# LUDLUM FIRST ADDITION TO SEDGWICK COUNTY, KANSAS

RE: S/D 00-01 -- One-Step Final Plat of LUDLUM FIRST ADDITION

RE: S/D 00-01 -- One-Step Final Plat of LUDLUM FIRST ADDITION

**CASE NUMBER:** S/D 00-01 -- LUDLUM 1<sup>ST</sup> ADDITION

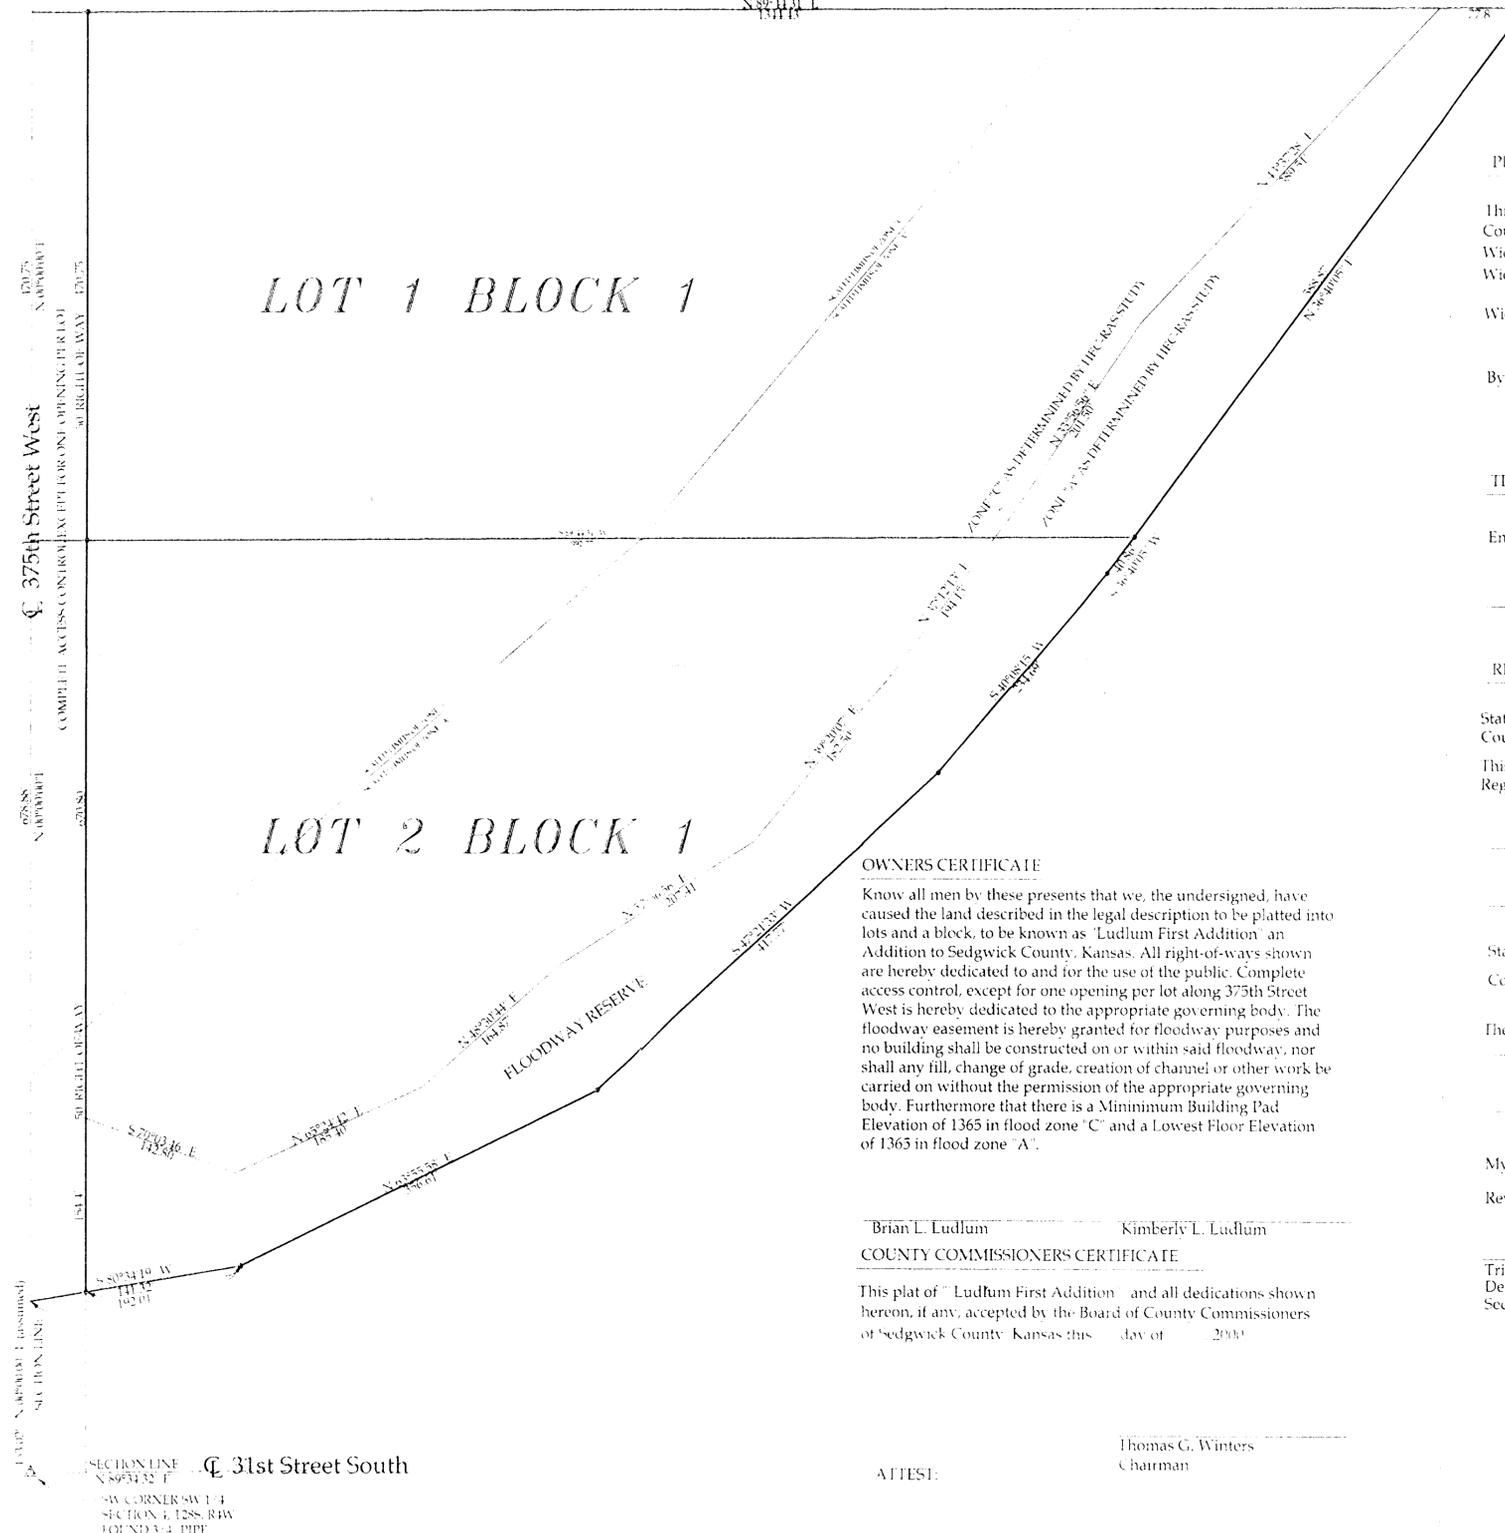
- D. **County Engineering** needs to comment on the status of the applicant's drainage plan. **The Floodway easement needs to be relabeled as a Floodway Reserve. The limits of the Floodway Reserve need to be labeled and dimensioned. The lowest floor or minimum building elevations need to be established as applicable. A HEC Quick-2 flood study run needs to be completed; which may require the revision of the floodway boundaries. A floodway reserve easement needs to be provided.**

- E. The plat proposes one access opening per lot along 375<sup>th</sup> St. West. The plat's text shall reference "one opening per lot" and denote access controls as being dedicated to the appropriate governing body.

- F. Lot line dimensions need to be revised for the north and south lines of Lot 1 and along the southerly line of Lot 2.
- G. The owner's certificate shall reference the language "platted into lots" and include a signature line.

- M. The MAPC signature block should be revised to reference "Francis S. Garofalo" as the MAPC Chairman.
- N. The legal description needs to be revised to accurately portray the land being platted. The distances on the drawing need to correspond with those denoted within the legal description.
